City of Worthington

Certificate of Appropriateness Application

Case # AR 102-12
Date Received 9-28-12
Fee $2
Meeting Date 10-11-12
Filing Deadline 9-28-12
Receipt # _____

McGarry Addition and Renovation
849 Oxford Street
Worthington, Ohio
43085

North retaining wall elevation

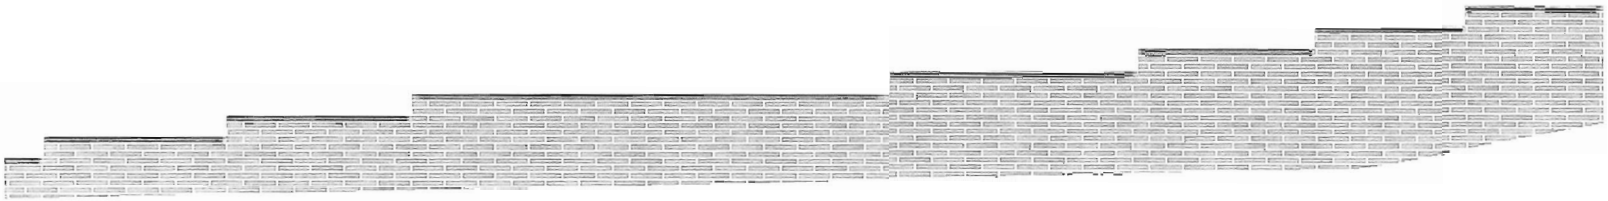
The original design proposal accepted by the ARB showed a north retaining wall with a sloping profile following the slope of the adjacent property to the north. (see approved North Elevation) During the ARB review and subsequent appeal process, the original foundation, chimney, and retaining wall cladding was changed to a manganese ironspot brick. Because of this change in material and module, from ¼" in height to the 2 3/8" height of a brick, a smooth top of wall was no longer possible. The wall follows the existing slope as closely as possible, and steps down at 8" intervals corresponding to this slope. The 8" dimension comes from the reinforced concrete block used instead of poured concrete- this change was also made to minimize impact on the neighbor's property.

A straight-line approach to the retaining wall would have caused the wall to project above the existing grade, making it much more visible from the neighbor's property. Our proposal is to cap the stepped brick areas with a charcoal pre-cast profile to match the grout color (see North retaining wall elevation drawing).

manganese ironspot brick with precast charcoal -colored cap to match grout
